Hexham Long Term Train Stabling Facility Modification 2 (SSI-6090-Mod-2) – Response to Submission

Table 1 DPE comments and response

Table 2 Newcastle City Council comments and response

Table 3 TfNSW comments and response

Development Trips - PM Peak

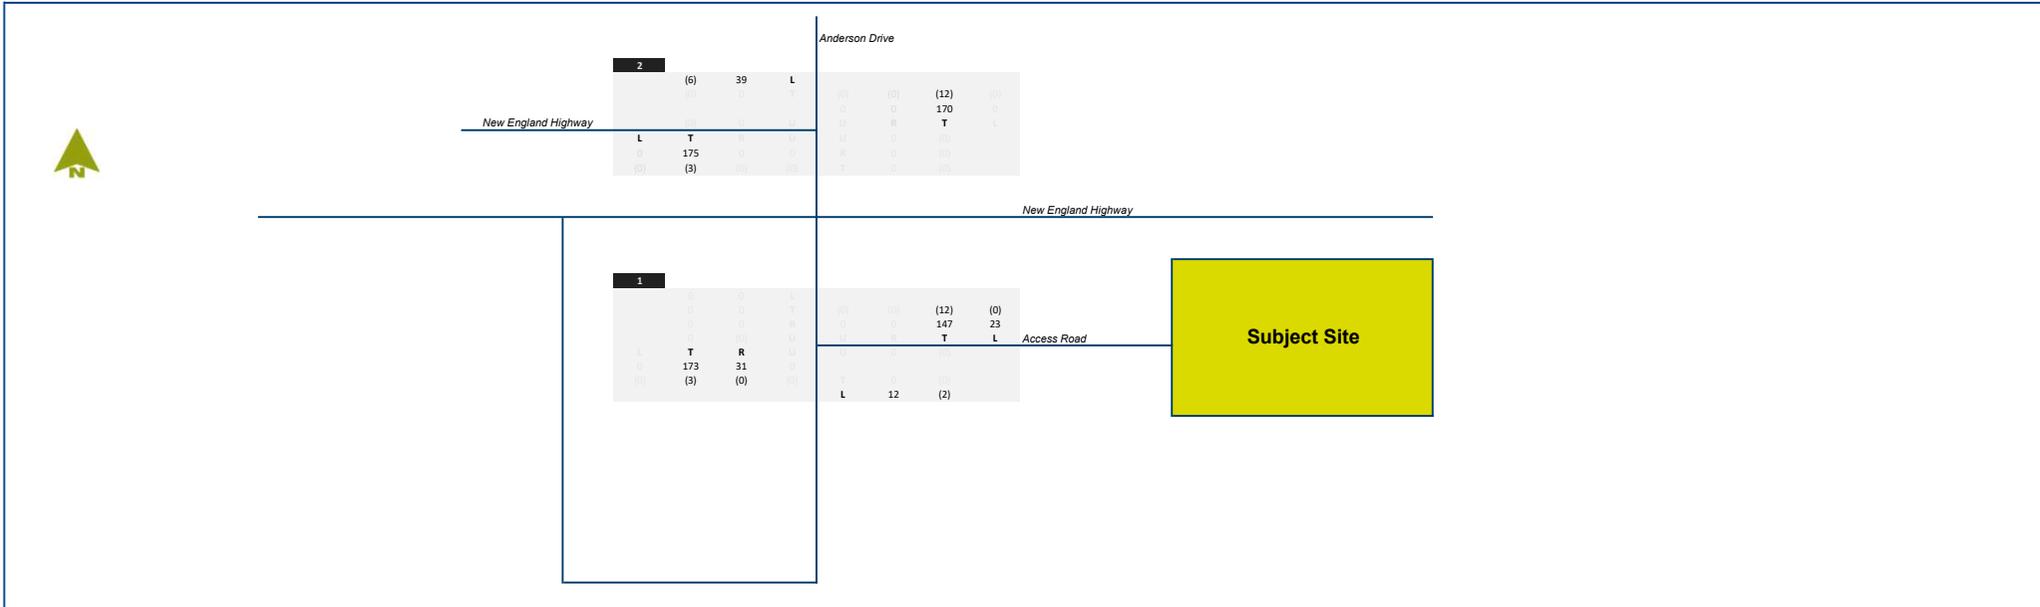
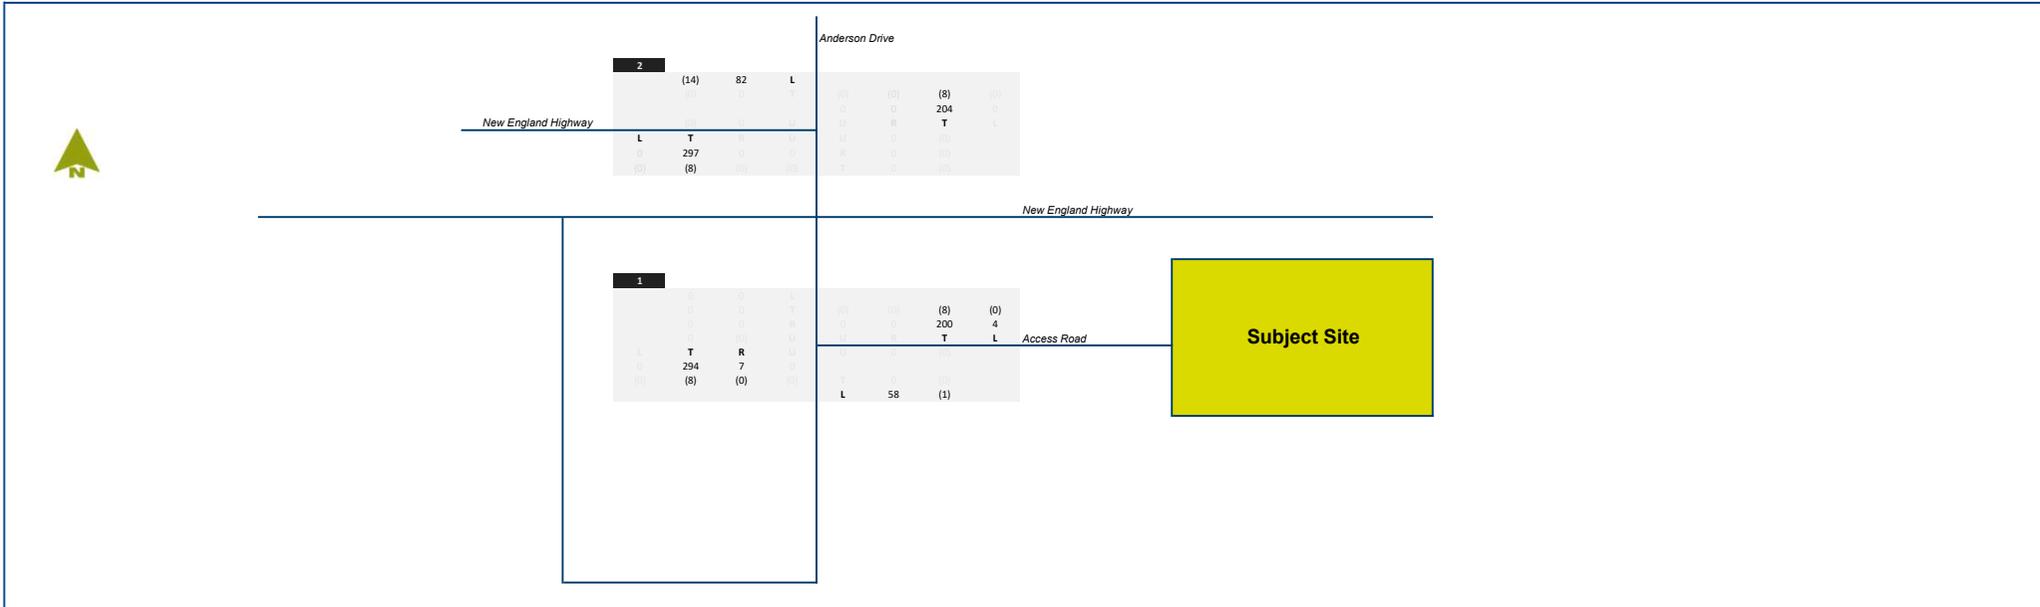
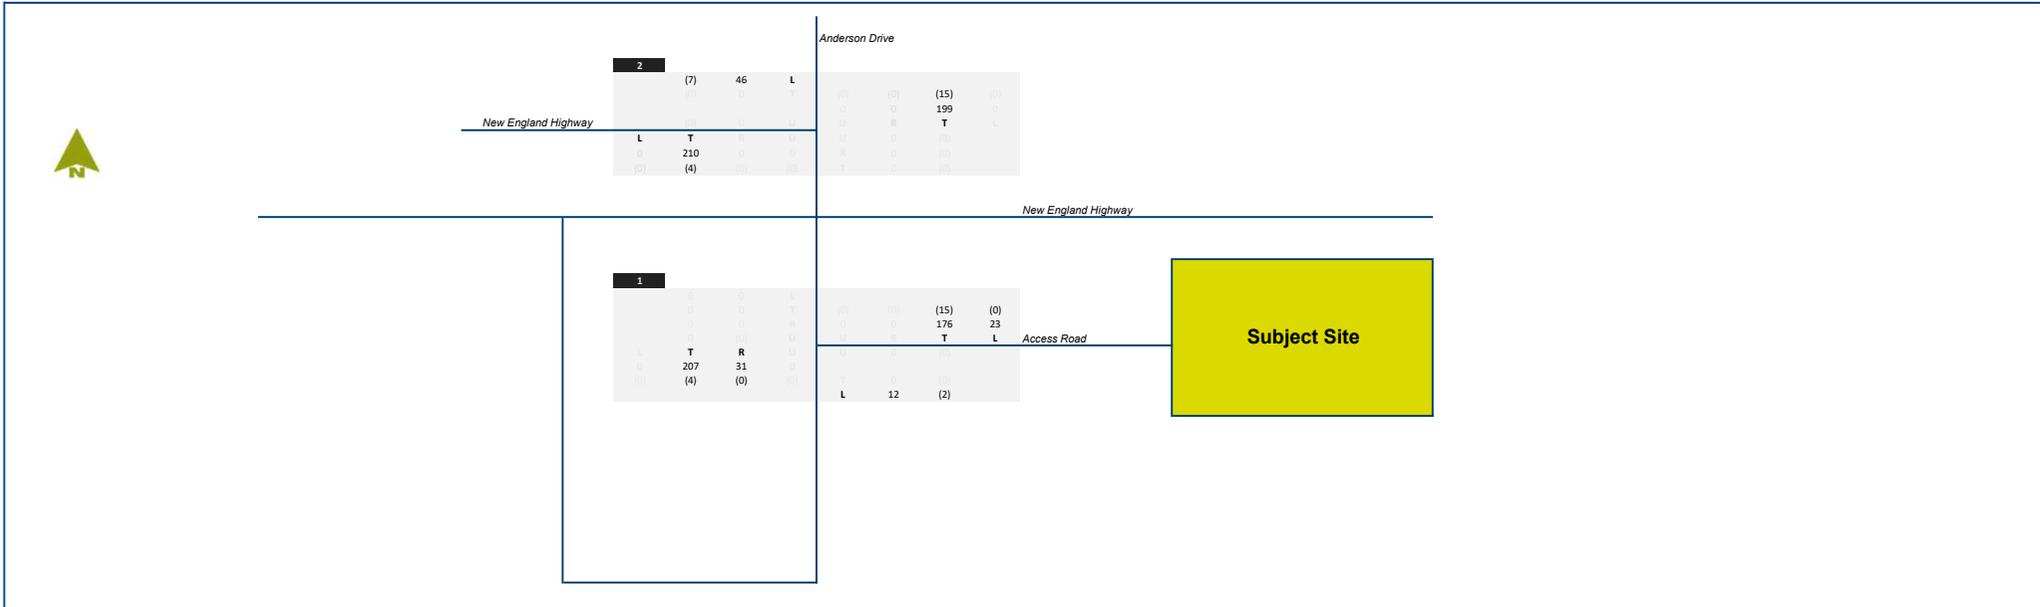
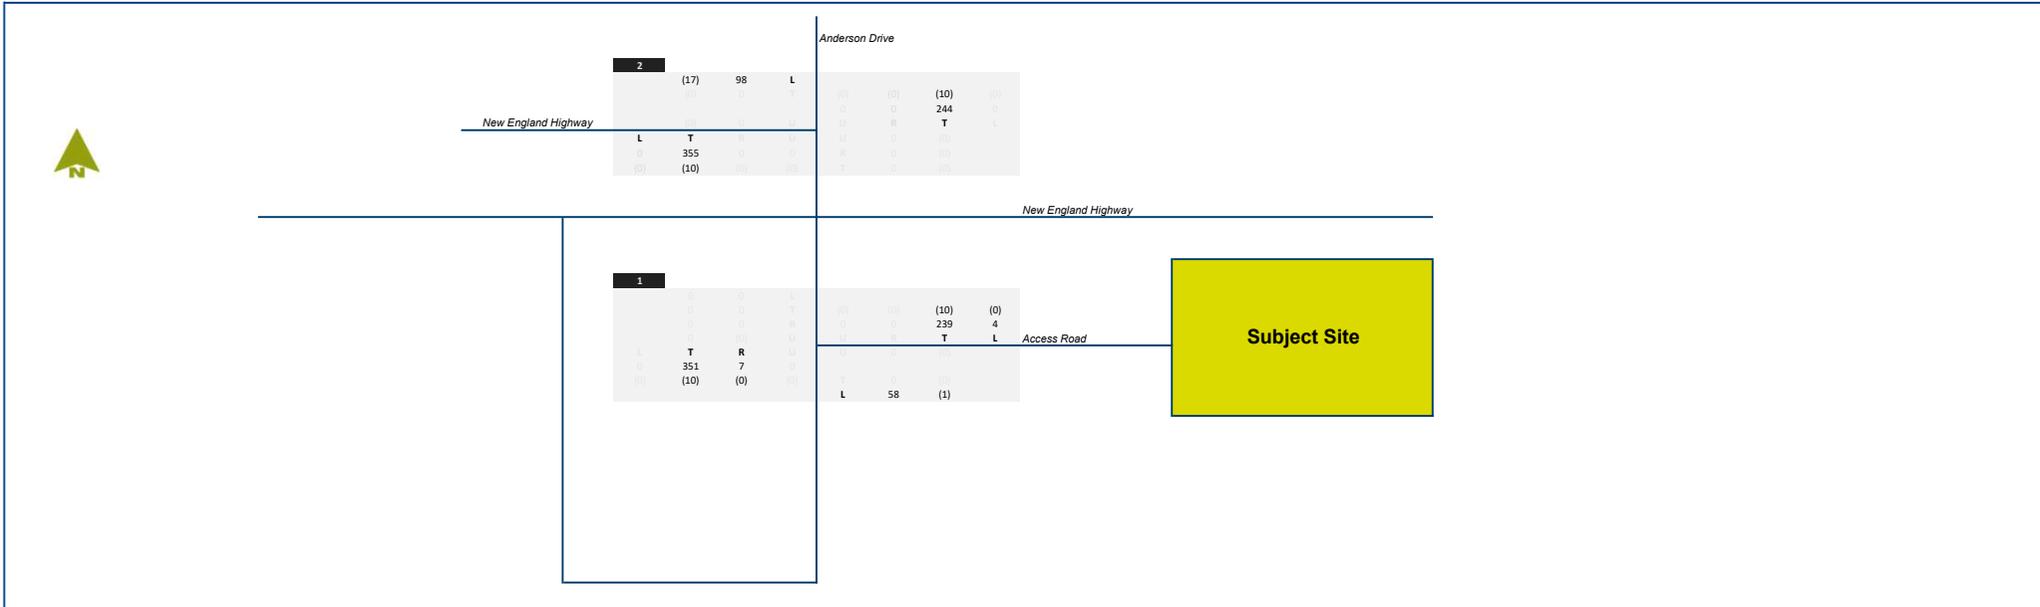
Aspect	Comment	Response	Reference
Intersection model	The submitted Traffic Impact Assessment (TIA) has undertaken an analysis of the current State road network. The model however has identified vehicle movements inconsistent with the current road layout. For example, I1 has no right turn movement out from the Access Road, and I2 has no right turn movements out from the New England Highway off-ramp. These should be amended as part of a revised TIA.	<p>SLR has provided updated traffic flow diagrams (Attachment D of this RtS) which consider the removal (and re-assignment) of the existing and forecast illegal right turn movements at the Tarro interchange. These diagrams also provide a breakdown between light and heavy vehicles.</p> <p>The updated traffic movements have been input into the SIDRA traffic model. Summary output from the revised modelling (Attachment E of this RtS). Updated SIDRA model files are also supplied for review (submitted under separate cover). As identified from the updated SIDRA outputs, the Modification Proposal would, with the redirection of these illegal turns, not result in an increased level of service at the identified intersections. The traffic impacts of the Modification Proposal are therefore considered minor.</p>	Attachment D and Attachment E of this RtS

SLR has provided updated traffic flow diagrams (**Attachment D** of this RtS) which considered the removal (and re-assignment) of the existing and forecast illegal right turn movements at the Tarro interchange. These diagrams also provide a breakdown between light and heavy vehicles.
